Draft label proposed under ESPR for iron and steel – ECOS methodological analysis of JRC paper and recommendations

Brussels, September 2026

Table 6. Thresholds for the classes of performance of HRC steel.

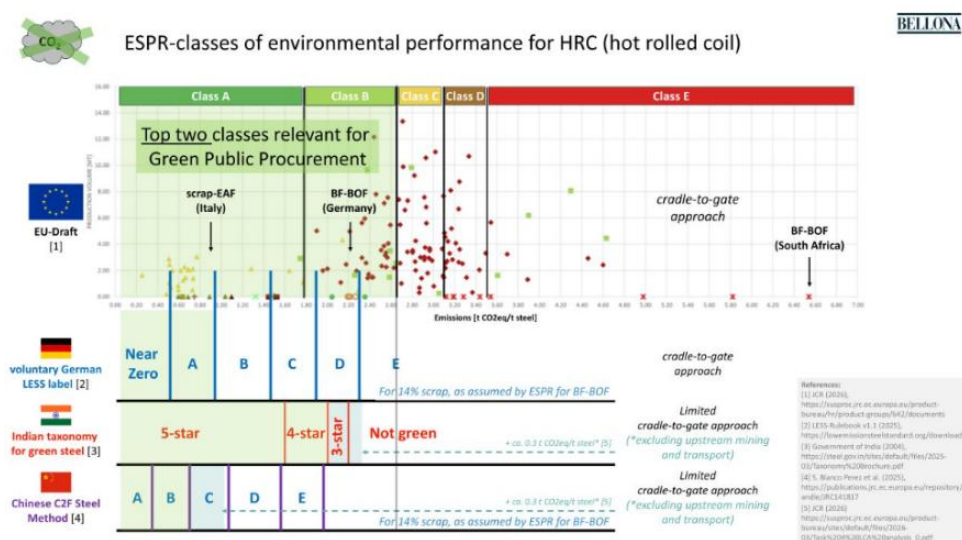
The JRC study proposes this classification into five classes for hot-rolled coil (HRC steel). Its most serious issue is the numerical values (cf. table 6). Best-in-class HRC should have up to 1.8 tCO₂eq/t of emissions. And class B, still eligible for public procurement (under ESPR Art. 65) runs through 2.66 tCO₂eq/t of emissions. However, most people familiar with steel will situate blast furnace (BF-BOF) steel around 2 tCO₂eq/t.

A comparison of labelling systems, developed by Bellona, shows what the best two classes mean for other labelling systems: 0.95 for LESS for BF-BOF steel, 2.3 for the Indian taxonomy (often ridiculed for calling almost everything green), and just above 1 for the Chinese C2F method – after adding 0.3 for upstream emissions to the Indian and Chinese scales, to compare like for like.³ It goes without saying that the limits for the other classes are also much higher than in other labelling systems.

“Some blast furnaces are green”

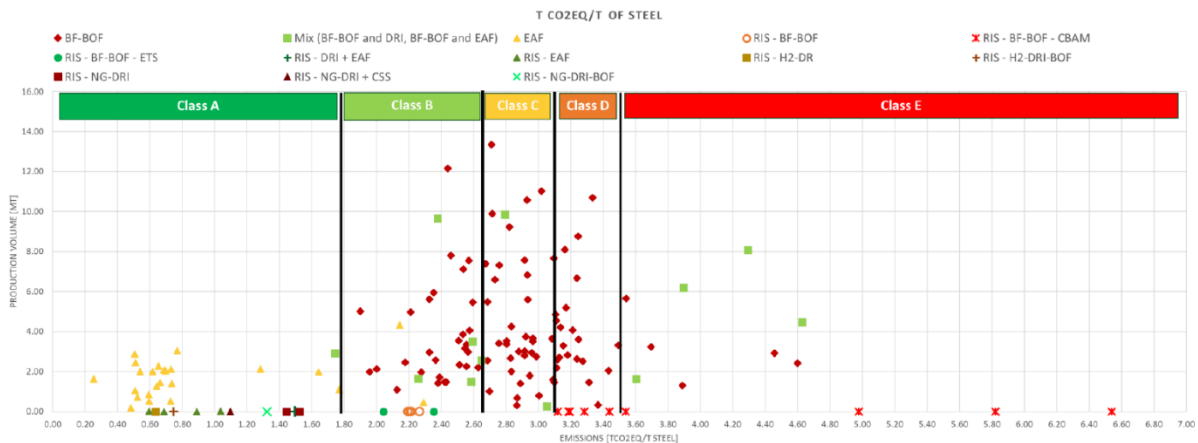
Let us first give some issues a closer look, before trying to understand them. Let us take figure 9 on p. 35 in the JRC report, showing data points on HRC.

First of all, there are two types of data points:

- Data points on plants (yellow triangles, green squares and dark red diamonds). Let us focus on the red diamonds, corresponding to BF-BOFs across the globe. These data points have an x value (their emission intensity) and a y value (the production volume of the plant). The x and y values are based on data from a commercial database by company CRU. *Based on* does not mean *taken from*, as scope 3 emissions are added subsequently, and the final result is then “scaled up” (see [this section](#)). The crude data from CRU cannot be accessed freely, but the JRC acknowledges in section 2 that some transformations were made to these data. See also [this section](#).

- Data points on “Reference Installation Scenarios”; these are the other symbols, all located on the x-axis. These data points correspond to fictitious plants with specific production techniques and geographical locations, built using a bottom-up methodology described in section 3. See also [this section](#) of the present document.

The study subsequently claims to set the classes in such a way that 30% of the production volume falls into the two top classes.⁹ It is worth mentioning that according to table 1 (p. 33), the actual percentage is 36.1%; **the reason for adding a further 6.1% is not clear.**

By sticking to the 30% (or 36.1%) logic (see also [this section](#) of the present document), inevitably the JRC study allows some BF-BOF into the top two classes, while the same report states that the label should be “ensuring that the classes drive continuous progress” (p. 3). This makes the document internally inconsistent, considering also that **blast furnaces are supposed to be phased out**. However, one could argue (but we would not) that continuous improvements from poor blast furnaces to state-of-the-art blast furnaces also reduce emissions.

Figure 2. Scaling up CRU database with scenarios for reference installations

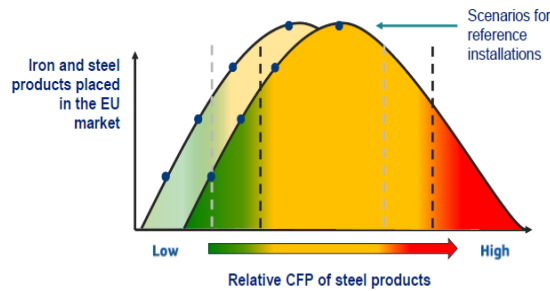
However, it is unclear how the raw data were transformed in the JRC's study. Based on the graph in Figure 2, the scaling up exercise appears to be simply a horizontal shift of the distribution, i.e. adding a constant value of emissions intensity to all data points. The wording "the scaling was performed using RIS" gives no information, thanks to the mathematical vagueness of the word "using", and the lack of any information on calculation formulae.

A simple shift by adding a constant value would not explain the extraordinarily wide spread of the JRC data other than by an extraordinarily wide range in the CRU data. Adding a constant value to all intensities would also mean that the same value would be added to BF-BOF and an EAF. This in turn would imply that coal mining (corresponding to the correction made to BF-BOF data points) and scrap recovery (that made to EAF data points) would have been considered to coincidentally have the same carbon footprint. The simple shift by adding a constant value is therefore not a plausible hypothesis.

Alternatively, different values could be used to shift the different groups of CRU data, although this would not correspond to what the coloured pseudo-Gaussians in Figure 2 illustrate. But let us stay with that hypothesis, which appears technically more sound. In this case the Reference Installation Scenarios (RIS) for BF-BOF (the orange circles in the light blue circle for the EU, and the red crosses in the purple oval and another three data points¹⁵ with much higher intensities for imports) would need to be used as a reference for the horizontal shift. Let us therefore have a closer look.

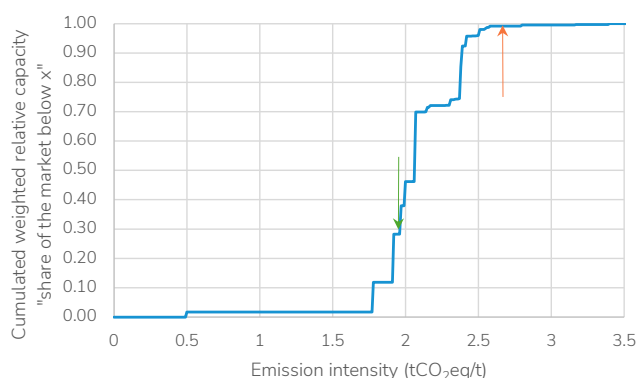
When 30% of the HRC on the EU market should fall in the two top categories, the cut-off between classes B and C should now be at an intensity of ca. 1.95 tCO₂eq/t (green arrow) – far away from the JRC’s proposal of a cut-off at 2.66 (orange arrow). It now becomes evident that such a threshold would have meant that more than 95% of the HRC on the EU market would have qualified as classes A or B.

Following the JRC's methodology – among others to have 30% of market volume in the top two classes, and applying our corrections, a classification scheme could look like this:

Class	Carbon footprint range (tCO ₂ eq/t)	
	JRC	after correction
A	0.00-1.79	0.00-1.00
B	1.79-2.66	1.00-1.95
C	2.66-3.10	1.95-2.35
D	3.10-3.75	2.35-2.75
E	≥3.75	≥2.75
